**PUBLIC NOTICE**  
**CITY OF BEXLEY ARCHITECTURAL REVIEW BOARD**  
**BOARD OF ZONING APPEALS**

Application No.: 11-0026  
Applicant: Joe Chay  
Owner: Joe Chay  
Location: 2738 E. Broad St.

**REQUEST:** The applicant is seeking Architectural Review to allow a 2<sup>nd</sup> floor deck and 2<sup>nd</sup> floor door, which were added to the front (south side) of the principal structure, to remain. **(Please Note: This application was tabled at the August 11, 2011 Board meeting.)**

## Structural Assessment Report

Picture 1 – Overall View of Deck

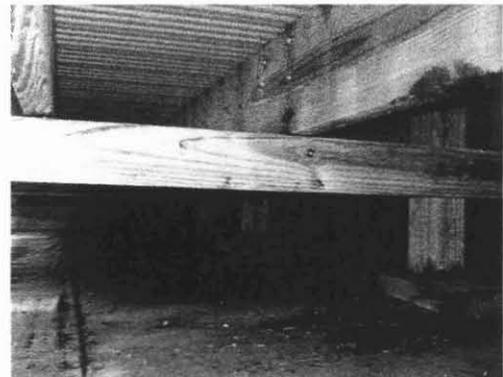
At your request, I performed a structural assessment of the recently constructed wood deck that was built on top of the existing low slope roof over the one-story portion of your home. The purpose of the assessment was to determine if the existing roof structure is adequate to support the additional loading associated with the presence of the new deck structure. The following paragraphs describe the findings and conclusions of the site visit.

**Site Observations:** The new wood deck is constructed from 2x8 pressure treated joists spaced at 16" on center supporting 2x composite decking. The 2x8 joists are supported by a series of 4x4 posts and double 2x4 cross beams. The posts form a rectangular array (grid) that effectively distributes the load evenly over the surface of the roof. Each post bears on a treated 2x6 plates that performs as a footing to protect the roof membrane from puncture.

**Conclusions:** The construction of the new wood deck meets engineering criteria and is structurally sound. The existing roof framing that supports this new deck has enough reserve capacity to support the additional weight of the deck.

Picture 3 – 2x6 Roof and Ceiling Joists Visible Thru Opening

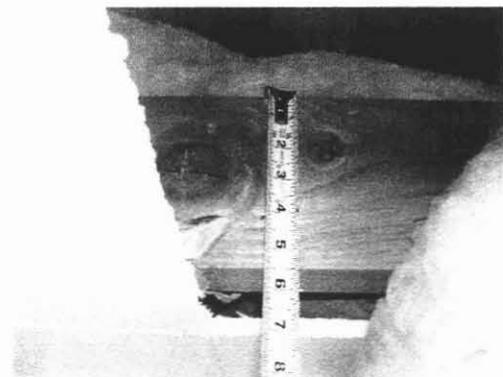
An access hole was cut in the existing drywall ceiling to directly observe the roof framing which consists of 2x6 roof rafters paired with 2x6 ceiling joists spaced at 16" on center. Assuming standard number 2 grade lumber, the existing roof framing system has enough capacity to resist the additional dead and live loads associated with the deck. Loading criteria was based on the requirements of the 2011 Ohio Building Code for roof live loads and snow loads.
